SHOAL CREEK ADDITION WICHITA, SEDGWICK COUNTY, KANSAS

RE: SUB 2000-22 -- Final Plat of SHOAL CREEK ADDITION (FORMERLY WHITEWOOD ADDITION)

At the regular meeting of the Subdivision Committee of the Metropolitan Area Planning Commission on Thursday, September 14, 2000, the above captioned plat was considered. The action of the Committee was to approve the final plat, subject to the following:

CASE NUMBER: SUB 2000-22 --SHOAL CREEK ADDITION (formerly Whitewood Addition)

JAMES D. ASHCRAFT, Sr. VP
JUDITH M. TERHUNE, Notary Public
JUDITH M. TERHUNE
My App. Exp. 11-11-2001

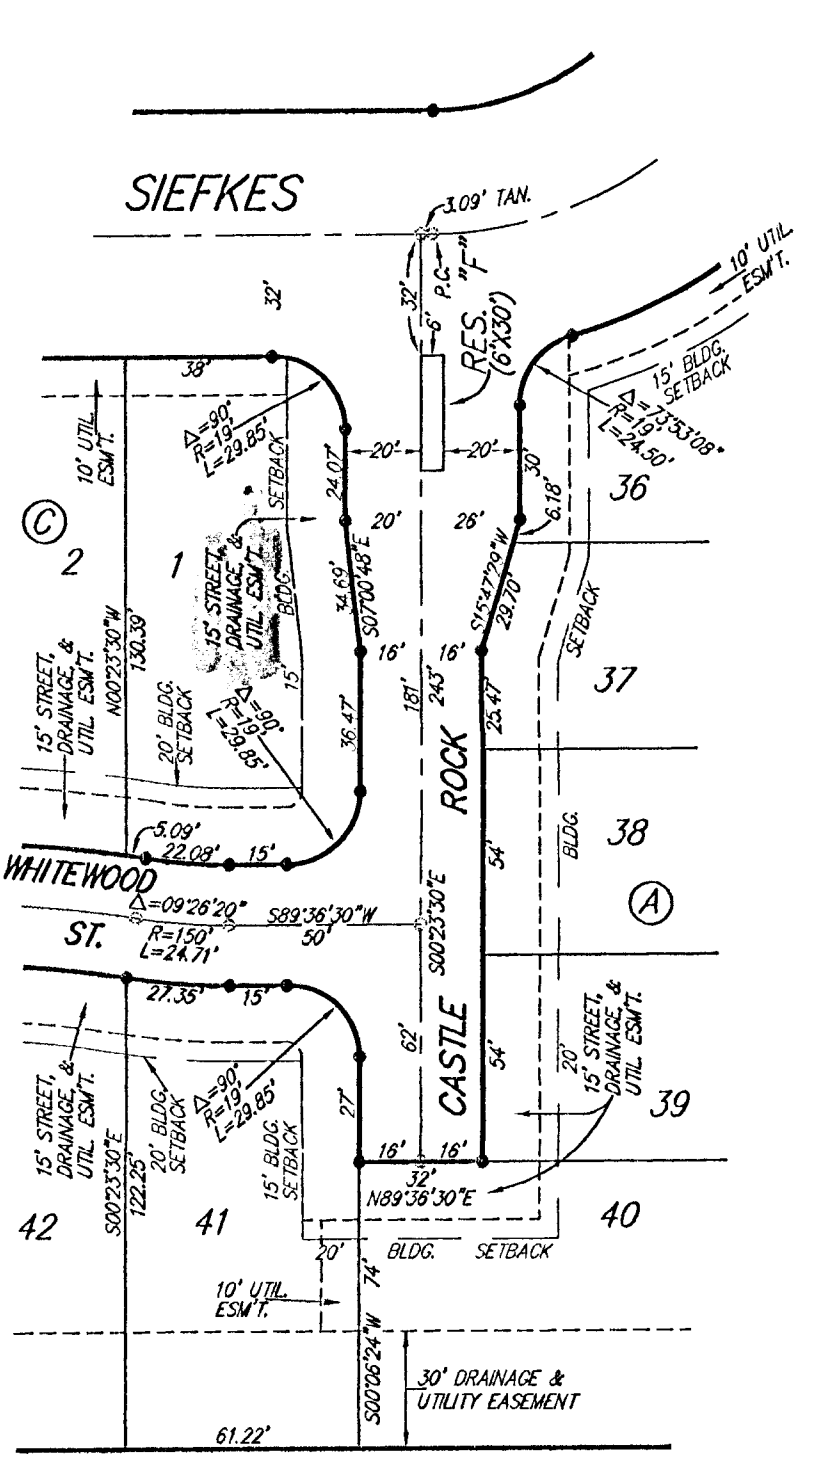
- B. The applicant shall guarantee the extension of sanitary sewer to serve the lots being platted. This guarantee shall be with the County for service through the Four Mile Creek sanitary sewer system. On the final plat tracing, appropriate wording shall be added to the Mayor's signature block indicating the City's agreement to allow a County sewer district to be formed within the City. **A revised sanitary sewer/utility layout is requested. Off-site sewer easements are required.**

- E. **City/County Engineering** needs to comment on the status of the applicant's drainage plan. **A drainage guarantee is required. As drainage from the site is directed onto the Kansas Turnpike, a letter shall be required from KDOT indicating their agreement to accept such drainage.**

- G. City Fire Department needs to comment on the 2,400-ft cul-de-sac (Siefkes/Whitewood Court) which exceeds the 1,200 maximum length standard of the Subdivision regulations. City Fire Department requests an emergency access easement to provide two points of access along Reserve D, Block A.

- K. The MAPC Policy Statement regarding Cluster Development states that each open space area shall be a minimum of 10,000 square feet and that no lot reduced in area shall be more than 500 feet from the nearest open space area. Lots 36-39, Block E are not located within the required 500 feet from Reserve E. A modification from this design standard has been approved.

- M. The lots in Block E shall be renumbered beginning with Lot 1.
- N. The terminus of Whitewood Court to the west shall be reconfigured as a circular turnaround.

- Q. The pipeline easement on Lot 26, Block E, needs to be located.
- R. A dimension needs to be added on Lots 5 and 6, Block D.

- S. Since this plat proposes the platting of narrow street right-of-way with adjacent "15-foot street drainage and utility easements", a restrictive covenant shall be submitted which calls out restrictions for lot-owner use of these easements. Retaining walls and change of grade shall be prohibited within these easements as well as fences, earth berms and mass plantings.

- T. City Fire Department needs to comment on the plat's street names. The City Fire Department has met with the Applicant to revise the street names.
- U. The applicant shall guarantee the installation of the interior streets. This guarantee shall include a sidewalk along one side of Whitewood/Siefkes. In lieu of sidewalks on Siefkes Court and Whitewood Place/Whitewood Court, the Applicant has agreed to submit an alternate sidewalk plan denoting sidewalks around Reserve E.

- V. The applicant shall submit a covenant which provides for four (4) off-street parking spaces per dwelling unit on each lot which abuts a 32-foot street. The covenant shall inventory the affected lots by lot and block number and shall state that the covenant runs with the land and is binding on future owners and assigns.
